PERMIT INFORMATION

Permit Number: C-1981-035 Mine Name: King Coal Mine Operator: GCC Energy, LLC Operator Address:	County: La Plata Operation Type: Underground Permit Status: Active Ownership: Federal			
Mr. Tom Bird 6473 County Road 120	Operator Representative Present:			
Hesperus, CO 81326	operator representative resent			
	Jordan McCourt			
Operator Representative Signature: (Field Issuance Only)				
INSPECTION INFORMATION

COMMENTS

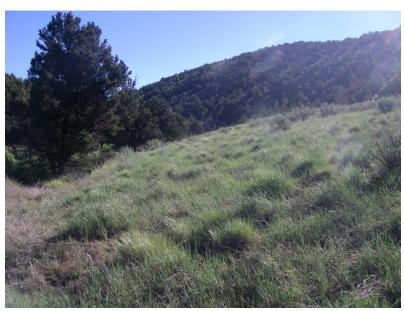
At King I, the recent earth work on the Plant Growth Medium Storage Areas looks to be adequate, although the south side of the pile above the Refuse Pile is not protected by a ring ditch. It appears to not be practical to put a ditch on that side of the pile due to topography and trees, but this area should be monitored very closely for erosion.
